W3F1-2020-0038

Subject: License Amendment Request to Implement a Digital Upgrade to the
Core Protection Calculator (CPC) system and Control Element Assembly
Calculator (CEAC) system

Waterford Steam Electric Station, Unit 3
NRC Docket No. 50-382
Renewed Facility Operating License No. NPF-38

Figure 2-2 Existing CPC/CEAC Architecture Block Diagram¹⁹

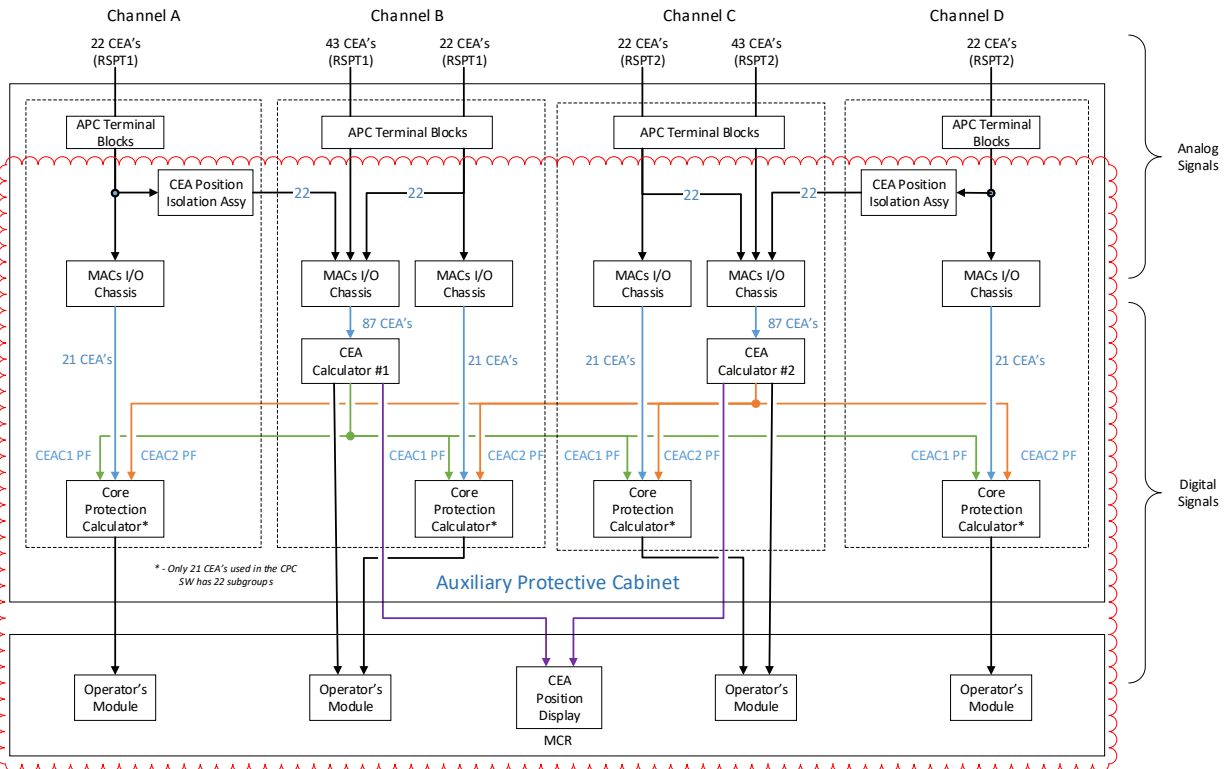
The area within the red box in the figure is what will be replaced for the CPCS modification. It should be noted that the CEA Position Display in the main control room (MCR) is a non-safety display isolated from the two CEACs called the CEA Position Display (CEAPD). This part of the system is not included in the LAR. The plant modification for CEAPD will be performed under 10 CFR 50.59.

Figure
7.2-3

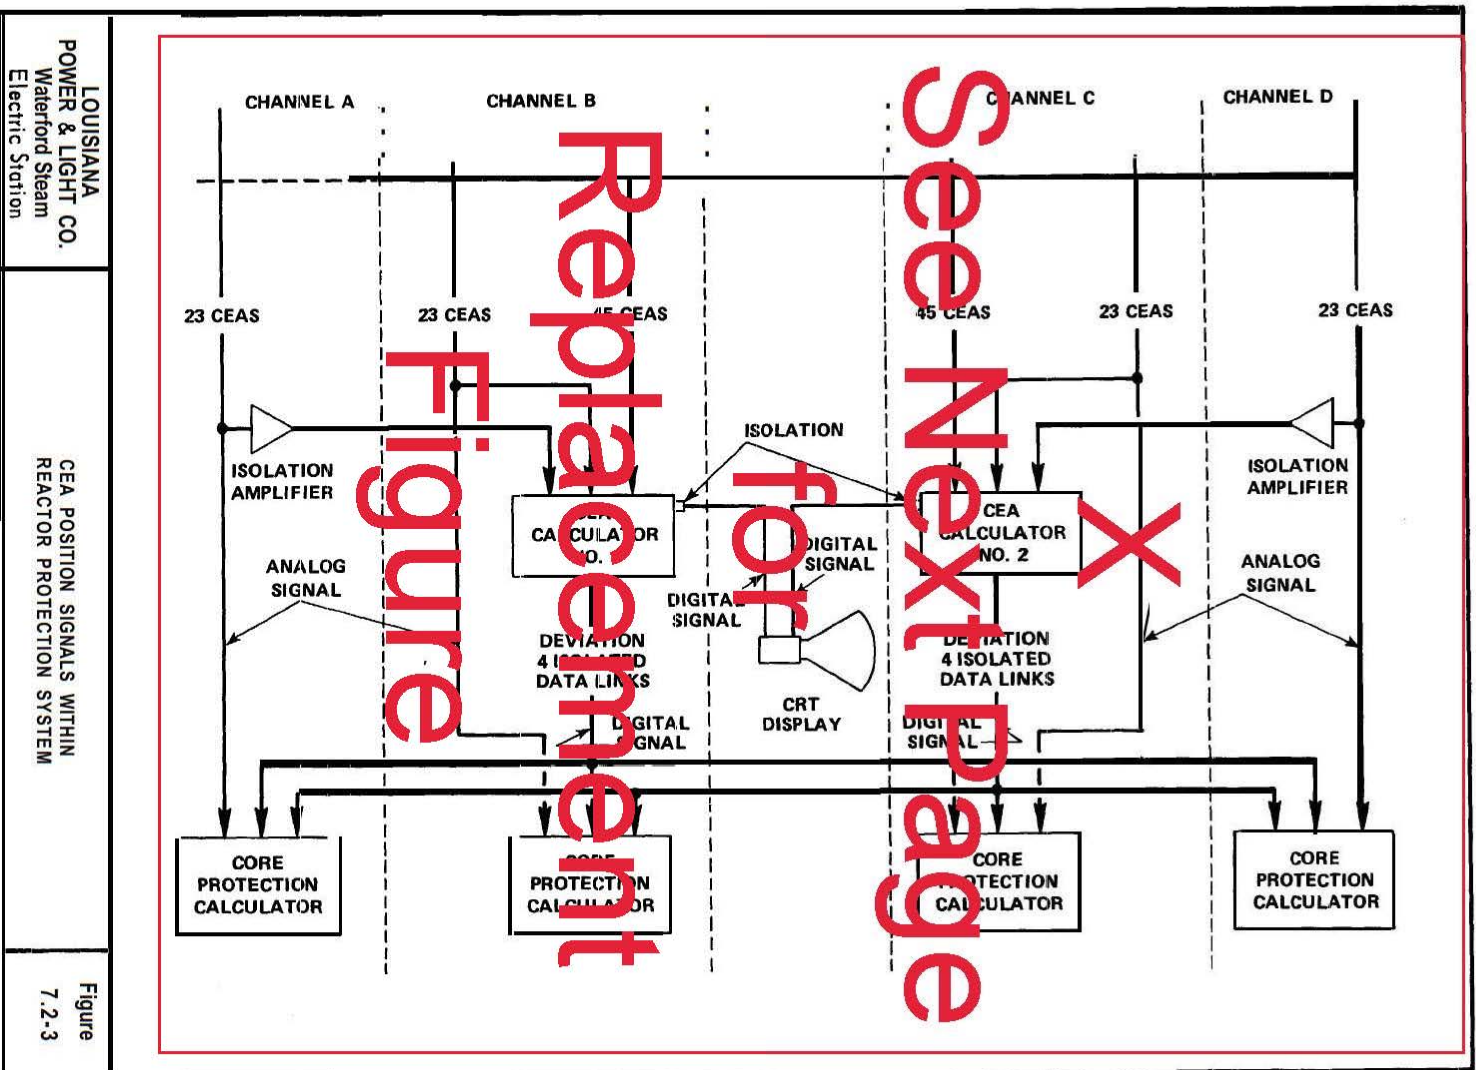
Add. in the one CPC channel that has the lost CEA Calculator.
